APPLICATION NO.	FILING DATE	FIRST NAMED INVENTOR	ATTORNEY DOCKET NO.	CONFIRMATION NO.
09/986,956	11/13/2001	Manuel Barbosa	1356-041	6385
25215 7590 02/28/2007 DOBRUSIN & THENNISCH PC 29 W LAWRENCE ST SUITE 210 PONTIAC, MI 48342			EXAMINER NGUYEN, XUAN LAN T	
			ART UNIT	PAPER NUMBER
			3683	
SHORTENED STATUTORY PERIOD OF RESPONSE		MAIL DATE	DELIVERY MODE	
3 MONTHS		02/28/2007	PAPER

Office Action Summary

DETAILED ACTION

FIG 1

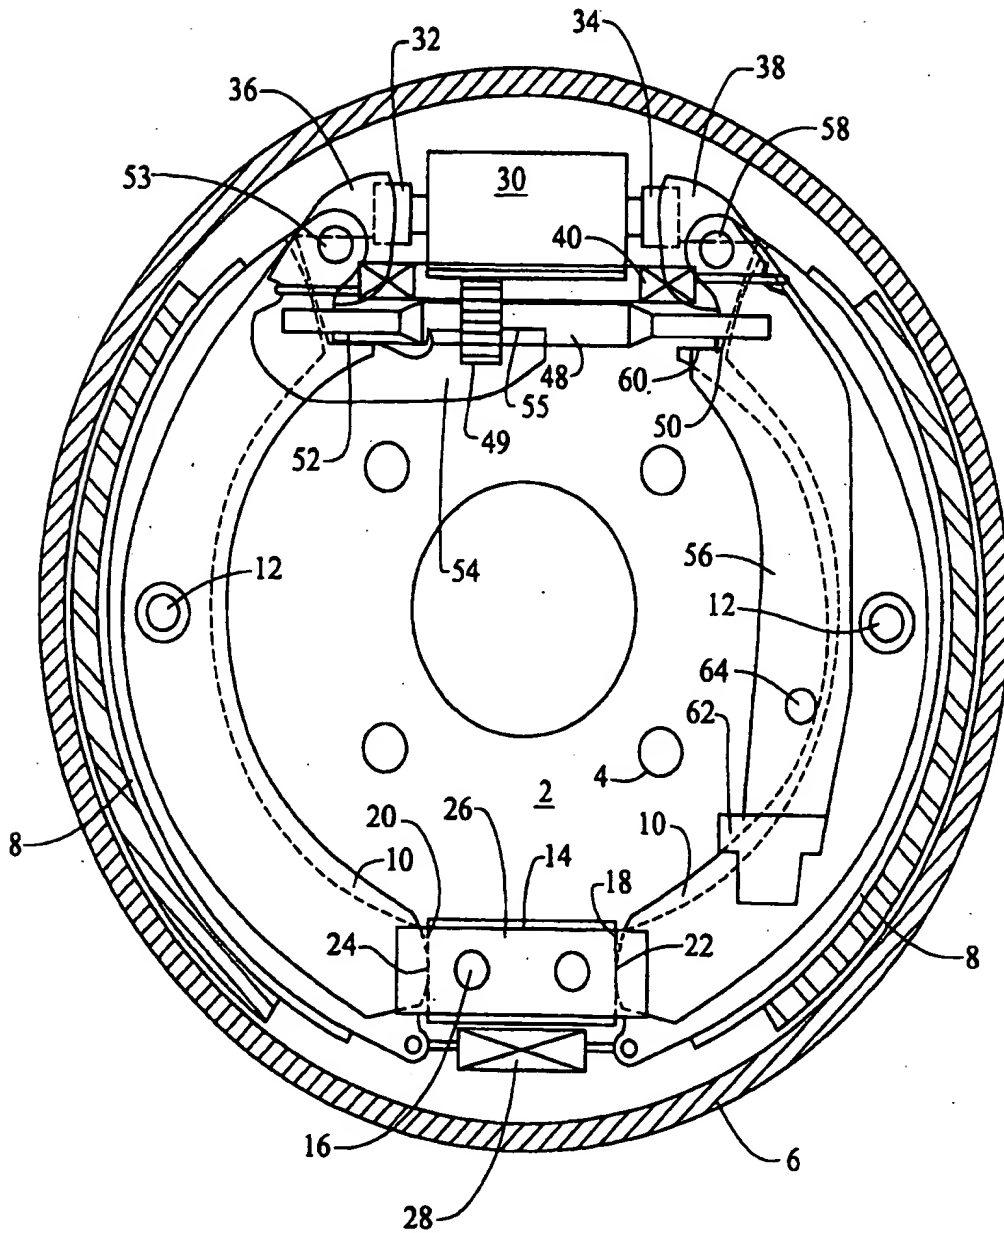
1. The drawings were received on 1/19/07. These drawings are not approved.
2. The drawings are objected to under 37 CFR 1.83(a). The drawings must show every feature of the invention specified in the claims. Therefore, the claimed feature "first and second actuating lever being configured to **selectively** engage the lower anchor block" in claims 15 and 26 must be shown or the feature(s) canceled from the claim(s). No new matter should be entered. Please note page 4 of the specification, paragraph 16 where it states "A spring 28 is connected between the ends of the levers to hold ends 22 and 24 to surfaces 18 and 20."

3. The drawings are further objected to under 37 CFR 1.83(a). The drawings must show every feature of the invention specified in the claims. Therefore, the claimed feature "a first spring for connecting the lower portion of the first and second brake shoes for maintaining contact of the first and second brake shoes against the surface of the lower actuating block" in claims 24 and 26 must be shown or the feature(s) canceled from the claim(s). No new matter should be entered. Please note page 4 of the specification, paragraph 16 where it states "A spring 28 is connected between the ends of the levers to hold ends 22 and 24 to surfaces 18 and 20."

NOT
approved
2/22/07
XLW

Corrected drawing sheets in compliance with 37 CFR 1.121(d) are required in reply to the Office action to avoid abandonment of the application. Any amended replacement drawing sheet should include all of the figures appearing on the immediate

FIG

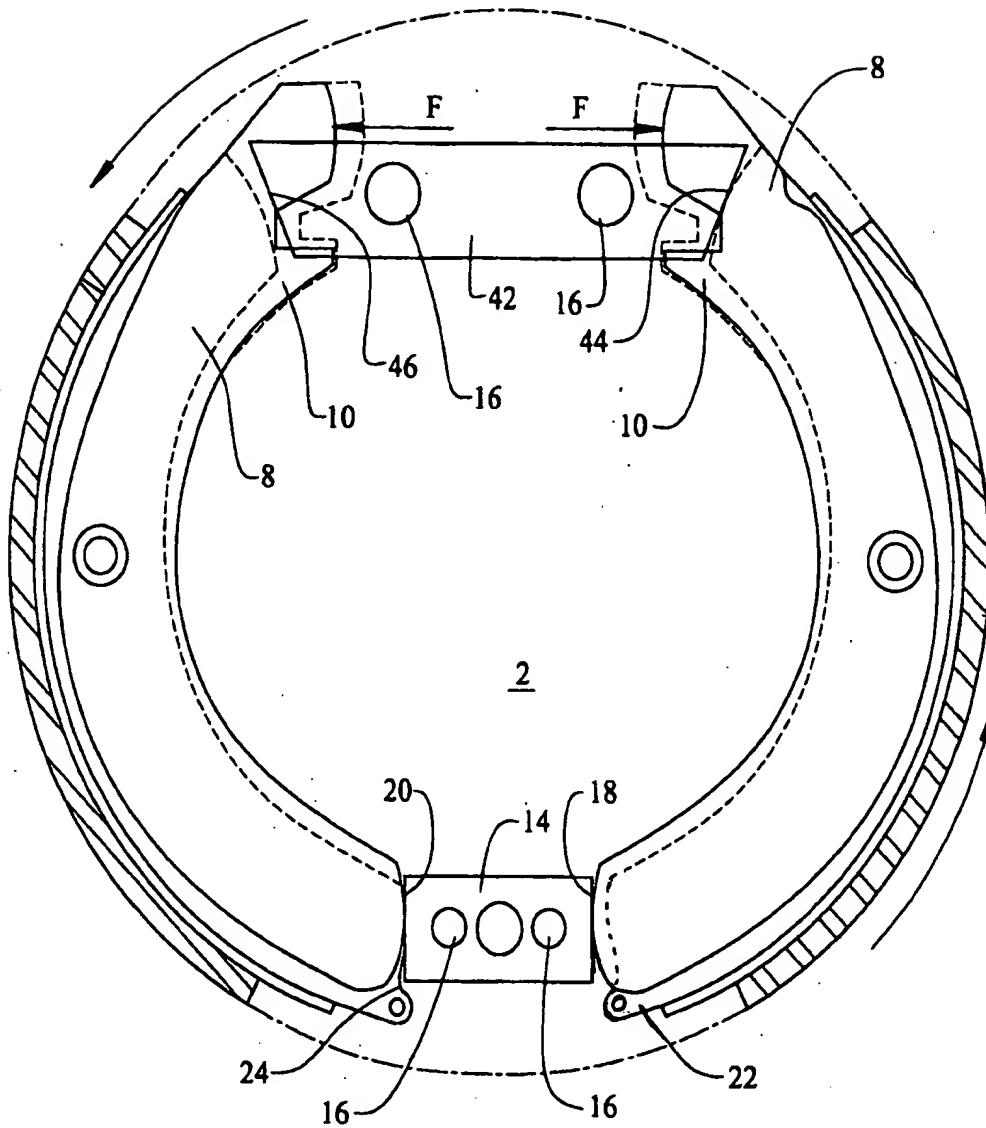
Not
approved
2/22/07
XLN
